# London Luton Airport Expansion

**8.118 Applicant's Response to Issue Specific Hearing 4  
Action 7 - Update on Road Safety Audits (Tracked Change  
Version)**

**8.118 Applicant's Response to Issue Specific Hearing 4 Action 7 –  
Update on Road Safety Audits (Tracked Change Version)**

Figure 3.445: Indicative A1081 Cross Sections

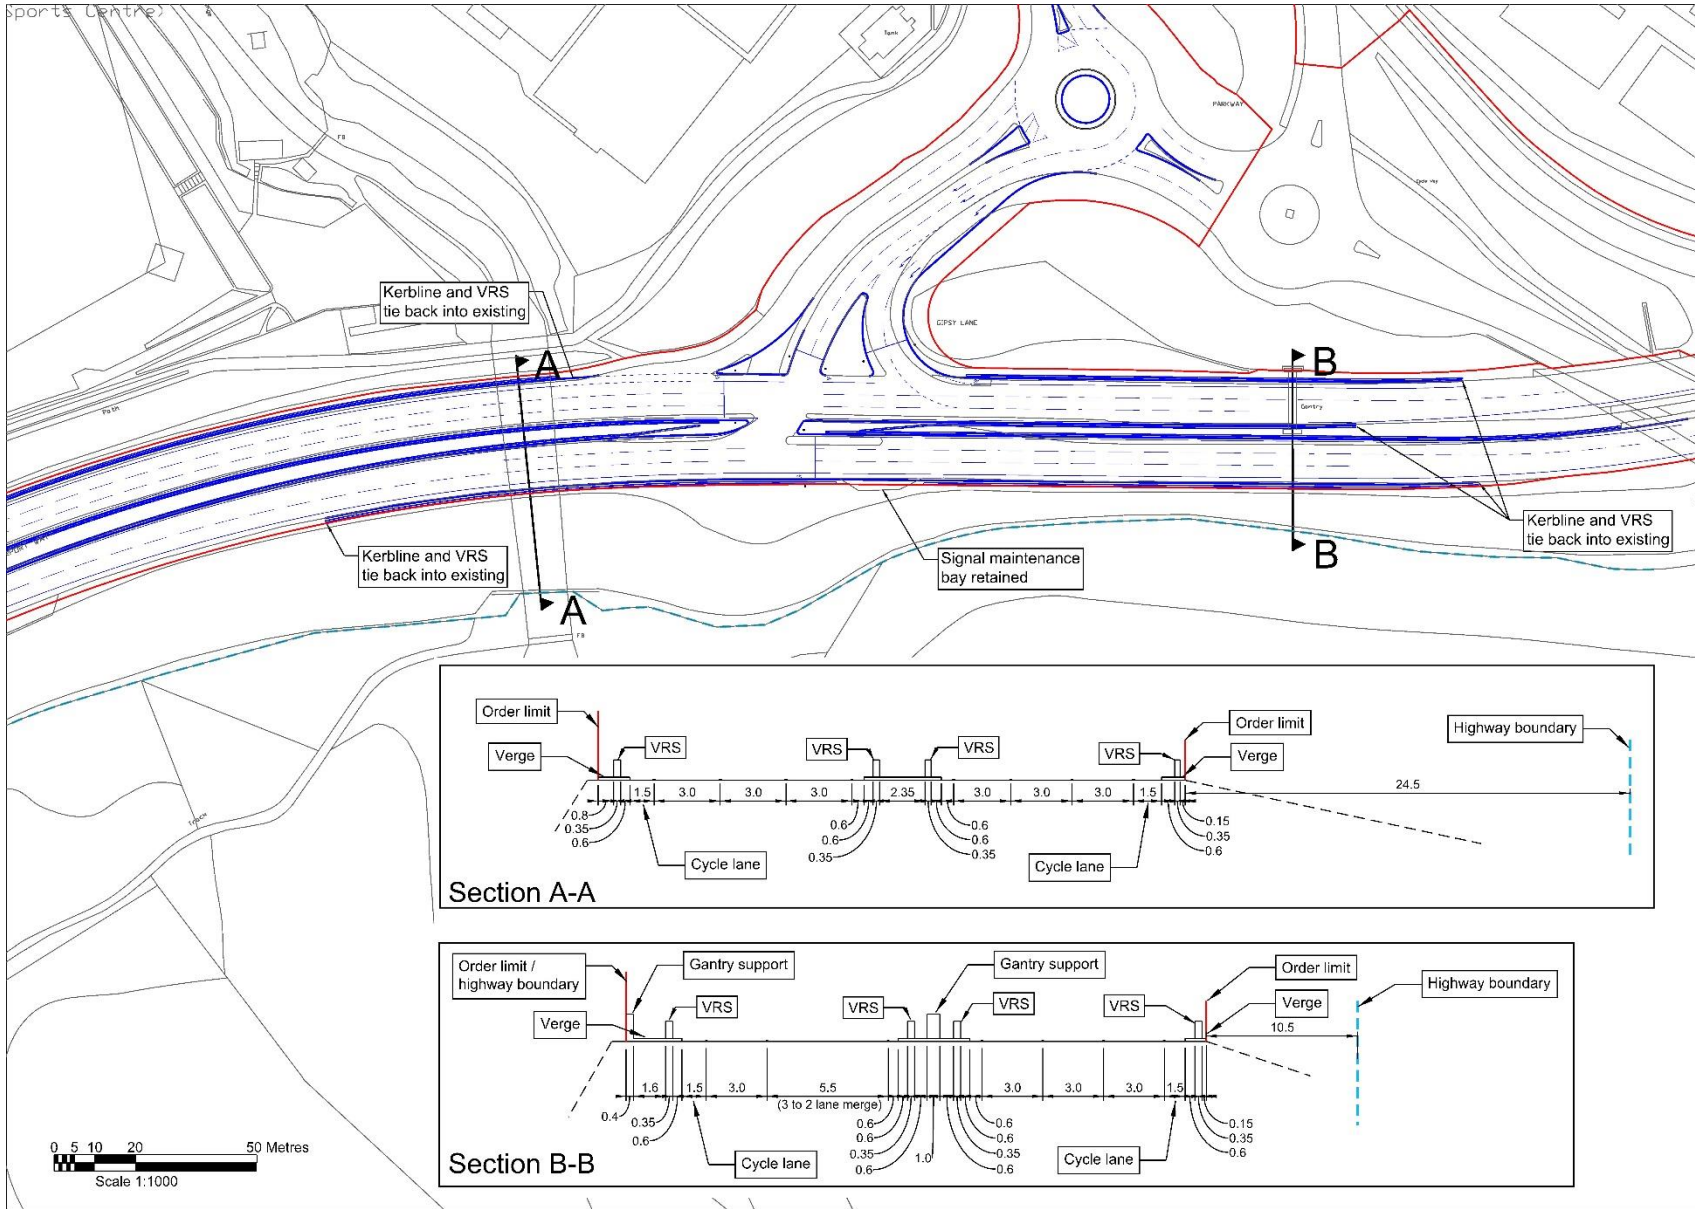
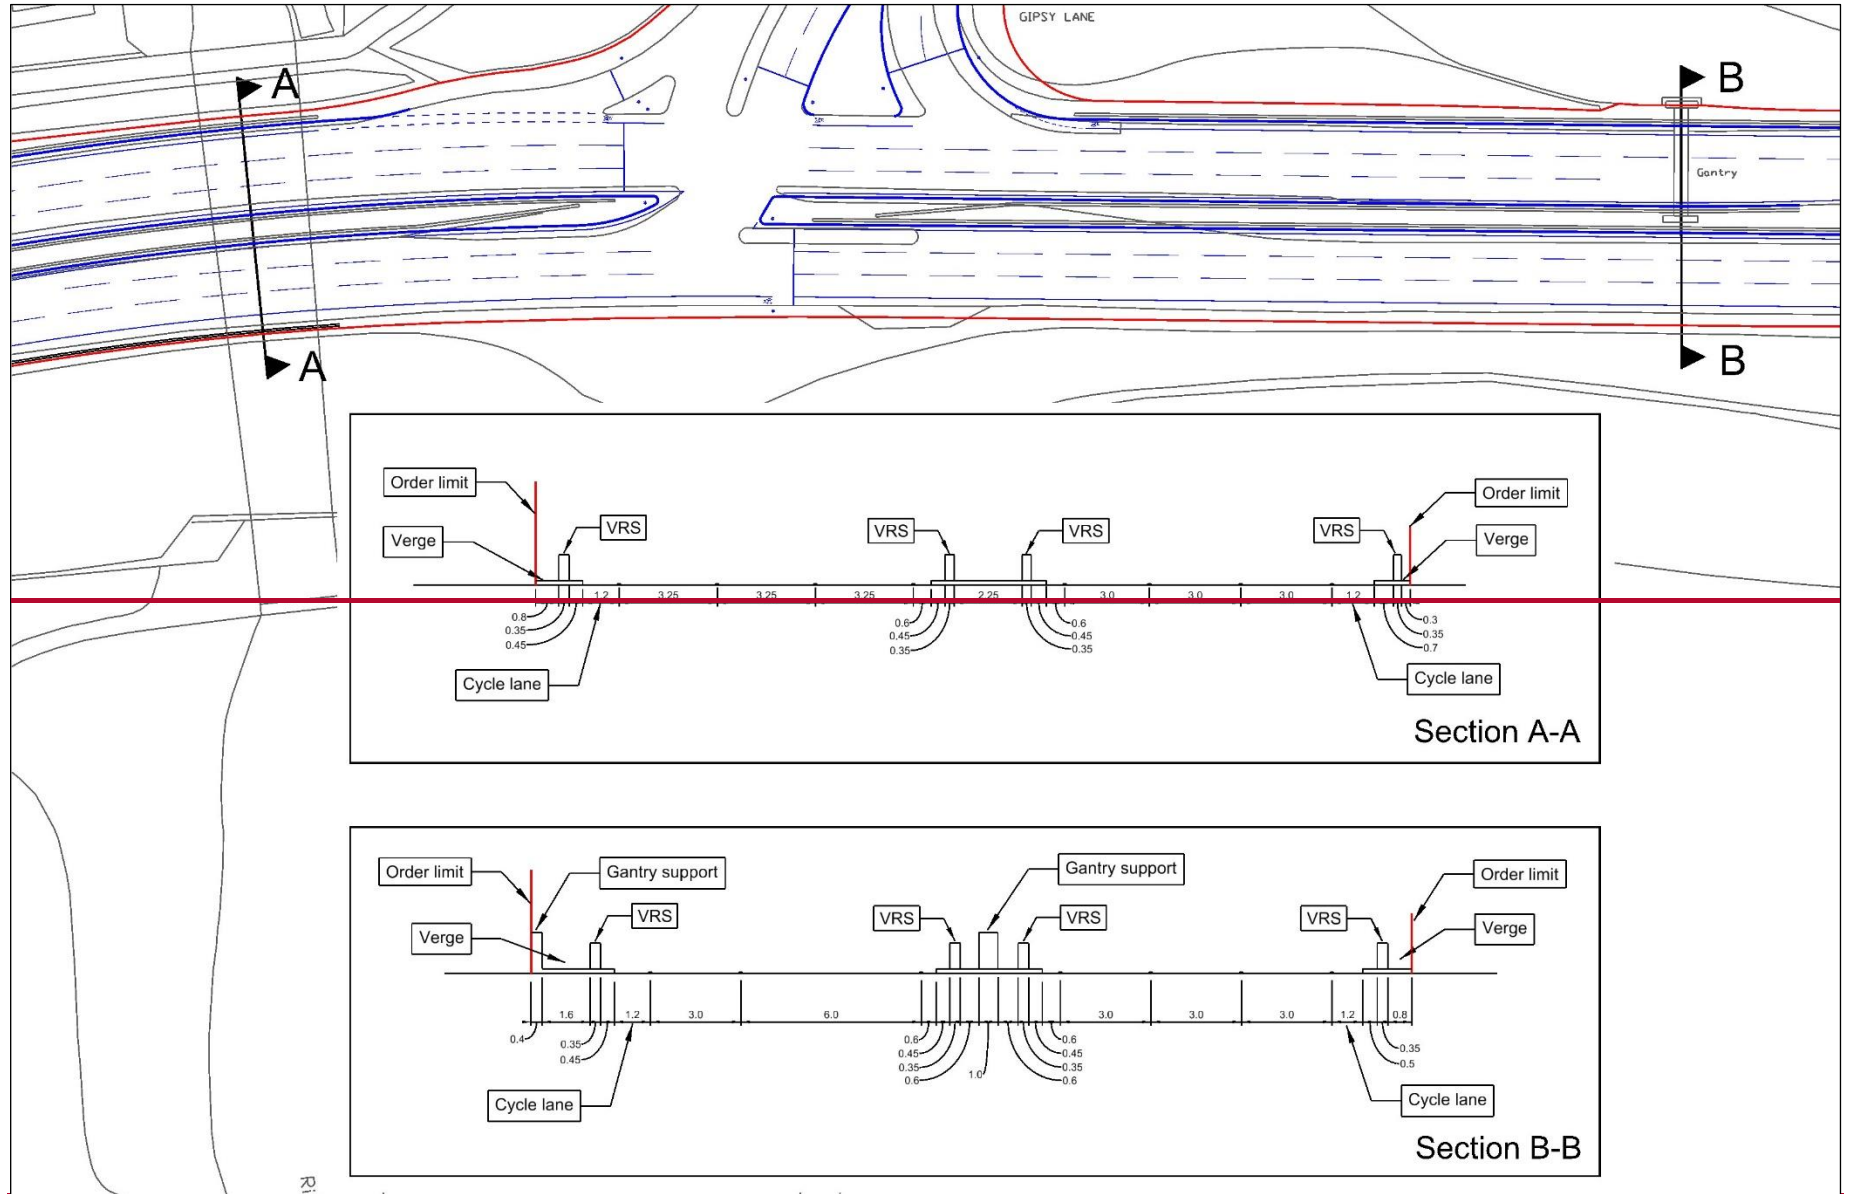
Ref.	RSA Problem	RSA Recommendation	Design Organisation Response	Overseeing Organisation Response	Agreed RSA Action
			<p><u>and for the existing A1081 cycle lane with a width of 1.5m to meet LTN 1/20 guidance. Indicative cross sections are shown on Figure 3.4.</u></p> <p><u>The side agreement allows for works to be undertaken within highway land, should this be required at the detailed design stage lane merge on the eastbound carriageway could be shortened creating more available width for the central reserve.</u></p>	<p><u>reduced cycle lane widths (on which further comment is made later). The updated layout provided as Figure 3.4 appears to substantially further reduce the width of the central reservation in the immediate vicinity of the overhead gantry, east of the junction, leaving limited clearance between the edge of the reservation and the gantry in the central reservation, whilst the widening required to maintain the cycle lane on the northern side of the A1081 appears to also bring the edge of carriageway closer to the northern gantry. It appears therefore that works to, or relocation of, the gantry are likely required if the Safety Audit recommendations are to be addressed. Whilst the gantry's northern pillar lies within adopted public highway, it falls outside of the DCO limits.</u></p> <p><u>It is also noted that the designs at present are at a feasibility level of detail and appear to be on an OS base rather than a topographical surveyed base. As such there is likely to be a further degree</u></p>

~~3.5.13.4.1 Figure 3.4Figure 3.4Figure 3.5, below, shows indicative cross sections at two locations along the proposed A1081 New Airport Way alignment, to the east and west of the junction. The western cross-section (Section A-A) is located at the narrowest point of the central reserve, noting that there is potential to reduce the length of three to two lane westbound merge, which would increase the central reserve width to the west of the cross section by up to 1m and t. The eastern cross-section (Section B-B) is located at demonstrates that there remains a significant clearance between the proposed realigned northern kerblines and existing gantry foundation.~~
